UNITED STATES  
NUCLEAR REGULATORY COMMISSION  
WASHINGTON, D.C. 20555-0001

SUBJECT: PEACH BOTTOM ATOMIC POWER STATION, UNITS 2 AND 3 - ISSUANCE  
OF AMENDMENTS RE: MAXIMUM EXTENDED LOAD LINE LIMIT ANALYSIS  
PLUS (CAC NOS. MF4760 AND MF4761)

Amendment No. 305  
Renewed License No. DPR-44

Figure 3.1-1 - MELLLA+ Operating Domain for PBAPS

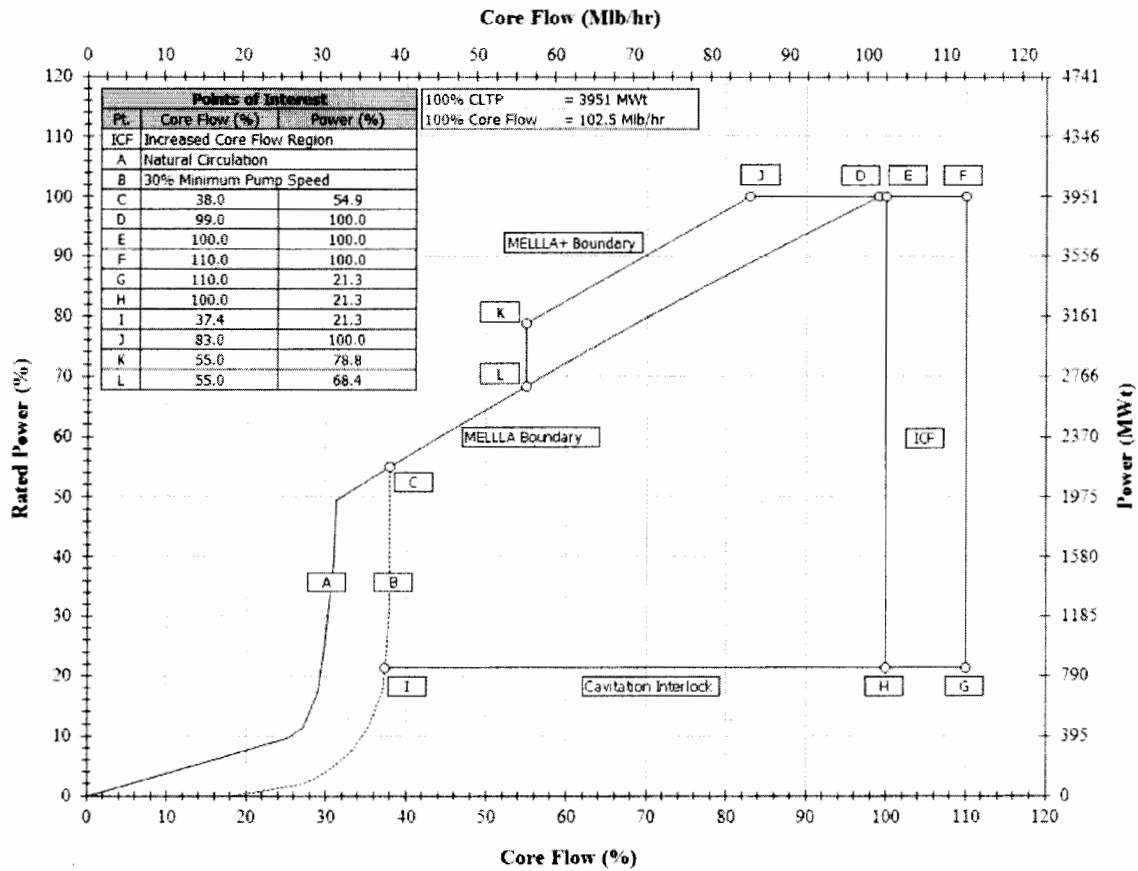
As discussed in SAR Section 2.2.1, as required by the M+ LTR Limitation and Condition 12.6, the SLMCPR is calculated at Statepoints E, J, K, and F (shown in Figure 3.1-1 of this SE). In addition, uncertainties for SLO are applied to Statepoints J and K. The calculated values will be documented in the SRLR.

At the MELLLA+ low corner (Point K of Figure 3.1-1), the power-to-flow ratio is maximized and there is the potential to encounter void formation in the bypass region. The NRC staff requested that the licensee determine the effect of bypass void formation on local power range monitors (LPRMs) and traversing incore probes (TIPs). The licensee's evaluation concluded that no bypass voiding is expected at the highest TIP elevation that corresponds to the highest LPRM detector elevation. This value is calculated using the ISCOR hot channel methodology, which is conservative, because it neglects cross flow between bundles in the bypass region.

- 12.23.5 – The PBAPS power density at the full power-minimum flow statepoint in the MELLLA+ operating domain (Point J of Figure 3.1-1) is 46.4 MWt/Mlbm/hr, which does not exceed the 52.5 MWt/Mlbm/hr limit.

The power-flow map (SAR Figure 1-1) shows Point F with 110% flow in the increased core flow (ICF) region. What is the maximum core flow that PBAPS can achieve? Is this a function of exposure (e.g., bottom-peaked shapes may result in reduced max achievable flow)? Is PBAPS susceptible to bi-stable flow in the recirculation loops? If so, what is the maximum (or range of) achievable recirculation flow used in normal operation to minimize bi-stable flow concerns?

Figure A-1 - Illustration of SLMCPR adders

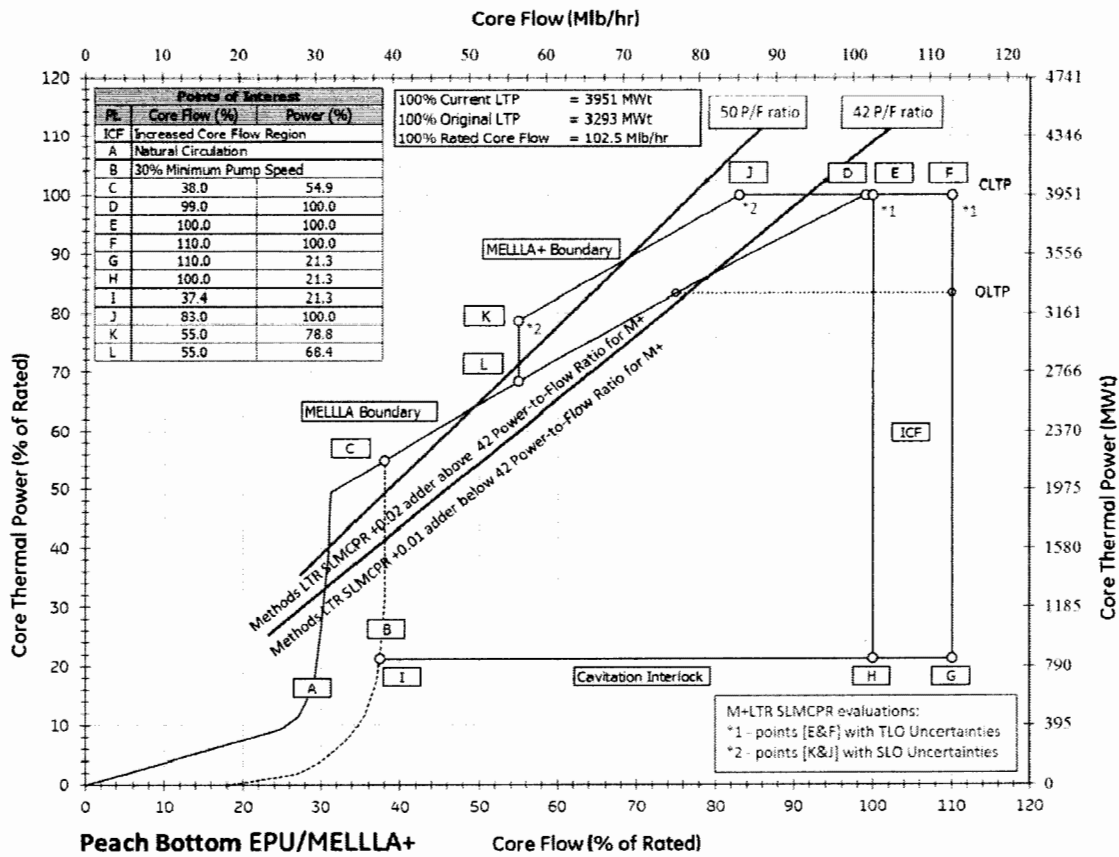
The licensee provided an illustration of the SLMCPR adder used as show in Figure A-1. For points J and K, which lie inside the MELLLA+ region, single loop operation (SLO) uncertainties are used. For Points F, E, D, and L, two loop operation (TLO) uncertainties are used. For all points, the Methods +0.02 adder is used conservatively, even though a value of +0.01 could have been used for points F, E, and D because they lie under the 42 MWt/Mlbm/hr line.

Conservative application of the +0.02 adder is acceptable because it will establish the most limiting SMCPR values in the Technical Specifications. This RAI is closed.

**Table A-2 - TTWBP-ATWSI Sensitivities PCT Results**

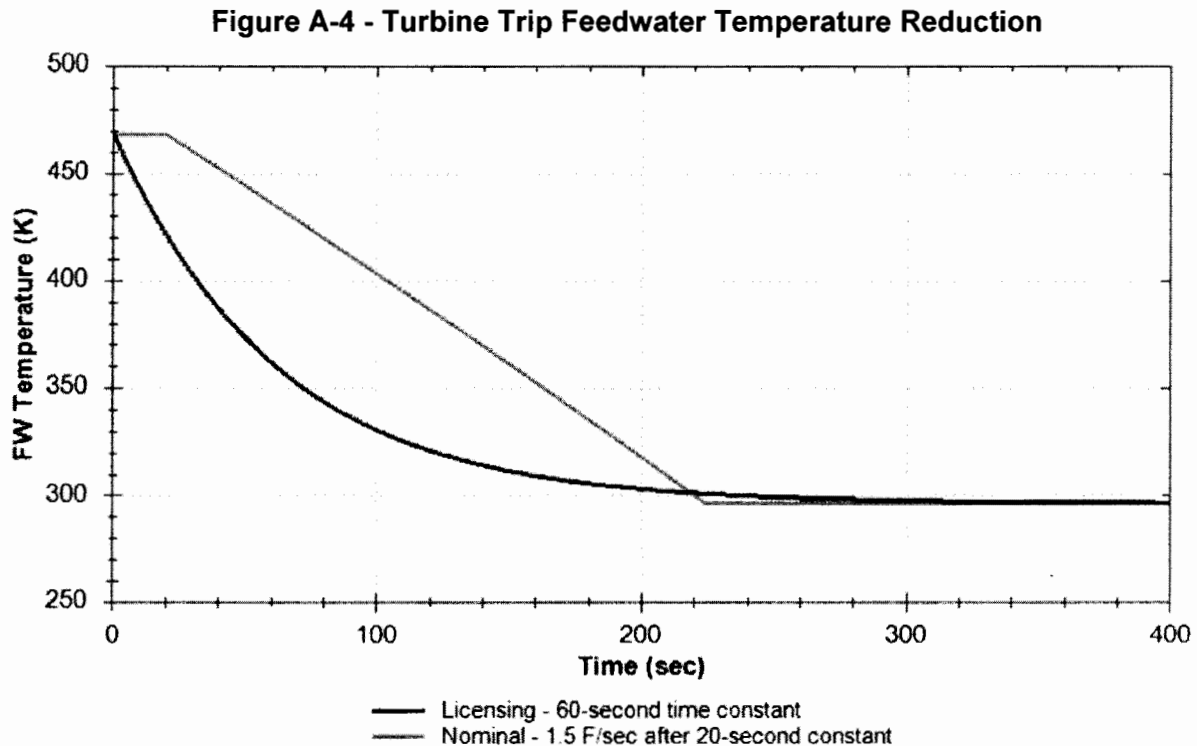
1. Feedwater cooling rate. Two cooling rates were used for the analysis:
  - a. A licensing case, where a 60 second exponential time constant is used to reduce feedwater temperature from nominal to condenser temperature.
  - b. A nominal case based on training simulator modeling where the cooling rate of 1.5°F/second is assumed following 20 seconds of the temperature remaining constant, which results in a slower cooling rate (see Figure A-4).
2. Operator action timing:
  - a. 90 seconds, 120 seconds, and 200 seconds to initiate feedwater flow reduction.
3. Hot rod peaking factor:

- a. [[                    ]], corresponding to 95 percent of the operating limit.
  - b. [[                    ]], corresponding to the actual PBAPS peaking factor at the exposure analyzed.
4. Tmin model. Two models were used:
- a. Modified Shumway Correlation.
  - b. THN, which is significantly more conservative.

The licensee provided the requested sensitivity calculations. Tables 1 and 2 of the RAI response (reproduced here, in part, as Tables A-2 and A-3) summarize the PCT results of TTWBP-ATWSI sensitivity calculations.
